FJ CRUISER

OUTLINE OF NEW FEATURES

The following changes have been made to the new FJ Cruiser.

07D5IN01

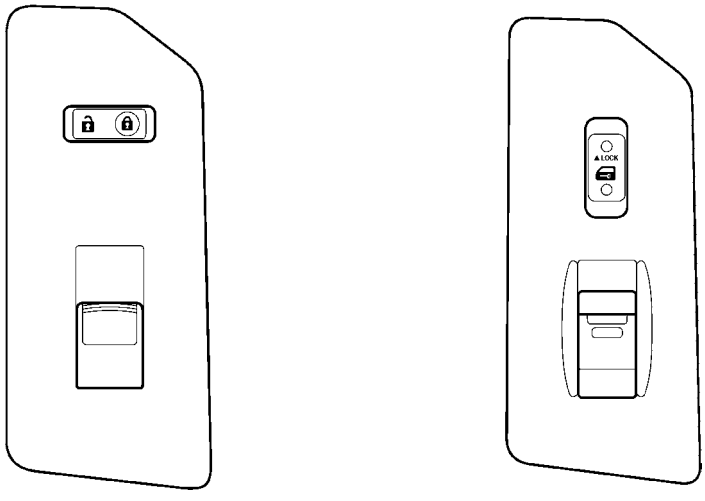
The design of the multiplex network master switch assembly and power window regulator switch assembly on LHD models has been changed.

▶ Multiplex Network Master Switch Assembly ◀

New **Previous**
